**PLANNED UNIT DEVELOPMENT,
PLANNING APPROVAL &
SUBDIVISION STAFF REPORT****Date: September 5, 2013**

<u>NAME</u>	Blue Creek Coal Terminal Subdivision
<u>SUBDIVISION NAME</u>	Blue Creek Coal Terminal Subdivision
<u>LOCATION</u>	80 Virginia Street (Area bounded by CSX Railroad, New Jersey Street, Old Water Street, and Mobile River, extending to the North side of Virginia Street, 465'± East of Conception Street))
<u>CITY COUNCIL DISTRICT</u>	District 2
<u>PRESENT ZONING</u>	I-2, Heavy-Industry District
<u>AREA OF PROPERTY</u>	1 lot / 36.9 acres ±
<u>CONTEMPLATED USE</u>	Planning Approval to allow a coal handling terminal in an I-2, Heavy-Industry District, Planned Unit Development approval to allow multiple buildings on a single building site, and Subdivision approval to create one legal lot.
<u>TIME SCHEDULE FOR DEVELOPMENT</u>	After appropriate approvals are obtained.

SITE PLAN

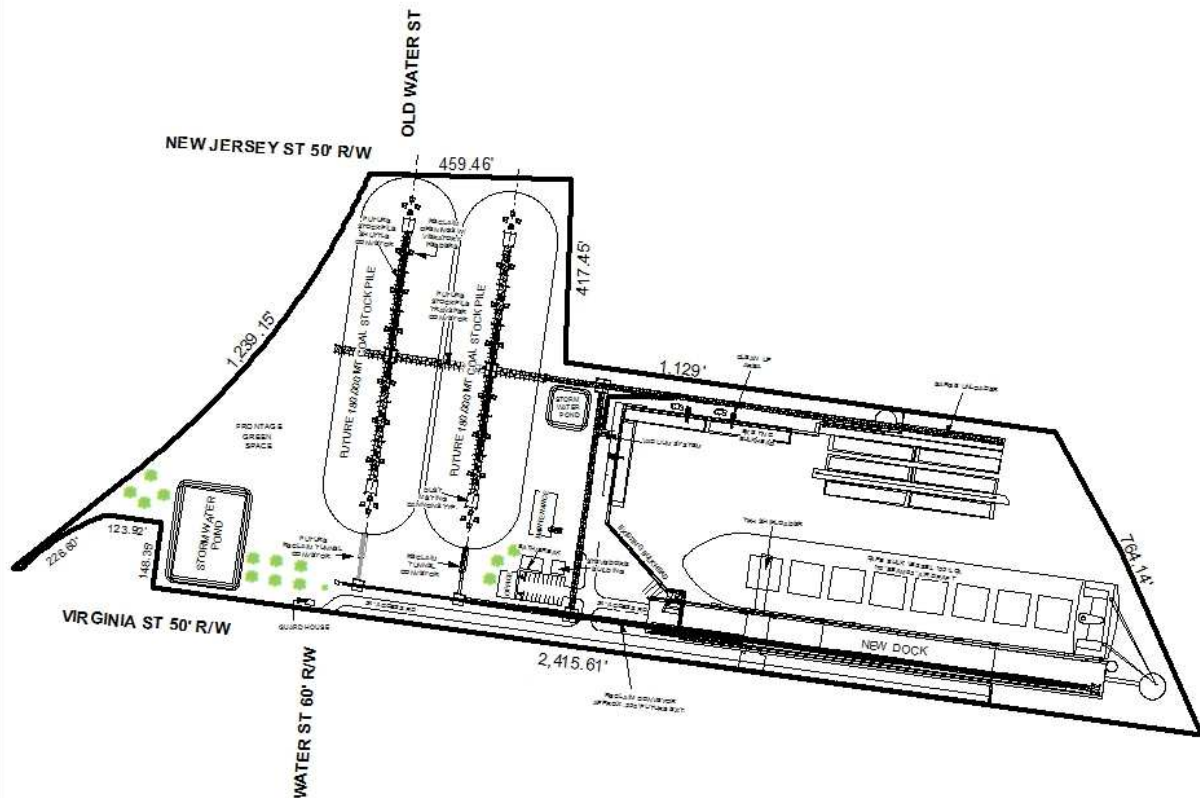
The site plan submitted with the application depicts one proposed curb-cut to Virginia Street. As PUD and Planning Approval review are site plan specific, the site should be limited to the single proposed curb-cut, with the size, design and location to be approved by Traffic Engineering, and to comply with AASHTO standards. It should be noted, however, that the presence of a guard building at the entrance to the site implies to staff that the entrance may be gated. If an entry gate is proposed, it should be depicted on the site plan and it should be set at least 60-feet from the right-of-way of Virginia Street so that emergency vehicles will have sufficient room to turn around if necessary.

The site plan depicts trees and landscape areas on the site. As the site is in an I-2 zone, only frontage trees are required. Calculations by staff indicate that 14 frontage trees are required, to be planted within the 25-foot setback along the Virginia Street frontage. Only 13 trees are depicted, and none appear to be within the setback area. Measurements of the site area by staff indicate that the non-navigable water portion of the site is no more than 22 acres of the total 36.9 acres. As such, the landscape area calculations on the site plan should be revised to only consider the dry land area, not any portion of the site over water (such as a dock), or the water area associated with the Mobile River: essentially any area behind the bulkhead should provide the basis for the landscape area calculations. The site plan and calculations should be revised to reflect the reduced landscape area requirements.

The site plan does not indicate which portions of the on-site access road will be paved, versus surfaced with aggregate or other materials. The site plan should be revised to depict paved versus aggregate surfacing. Additionally, the parking area should include concrete wheel stops if no curb-and-gutter will be provided.

Finally, the 25-foot minimum building setback line is depicted on the preliminary plat but is not depicted on the site plans. The site plans should be revised to also depict the 25-foot minimum building setback line.

A revised site plan indicates that the coal will be unloaded from barges utilizing a gantry continuous unloader with dust misting sprinkler with surfactant injection. The coal then travels by a conveyor with a continuous dust cover to the stockpiles, where it is deposited using telescoping dustless chutes. The stockpile dust is controlled using misting cannons. Coal is then transferred from the stockpiles to conveyors with continuous dust covers, with dust suppression fog cannons in use as the coal is moved from the stockpile to the conveyors, to the receiving bulk vessel. Coal is transferred from the conveyor system to the vessel by a dock conveyor with a dustless telescoping loading chute.

“dust misting cannons will be automated to operate based on the changing weather environment and weather forecast. Misting cannons will be equipped with surfactant injection system for stock pile dust control.”

- 1) Revision, if necessary, to label the correct size of the lot in square feet and acres, to match that on the final plat;
- 2) Revision of the site plan to depict any proposed entrance gate at least 60 feet from the edge of the Virginia Street right-of-way;

- 3) Revision of the site plan to depict the 25-foot minimum building setback line from Virginia Street;
- 4) Revision of the site plan to depict 14 frontage trees located within the 25-foot minimum building setback;

- 5) Revision of the site plan and landscape area calculations to only provide frontage and total landscape area based upon only that portion of the site that is actual land (that is, behind the bulkhead);

- 10) Development of the site must comply with all local, state and federal regulations regarding development within a flood zone;
- 11) Revision of the site plan to indicate which portions of the on-site access road and parking area will be paved in asphalt, concrete or similar, versus aggregate;

- 12) Depiction of concrete wheel stops in the parking area if no curb-and-gutter will be provided;
- 13) Submission of a revised site plan to the Planning Section prior to the signing of the final plat; and
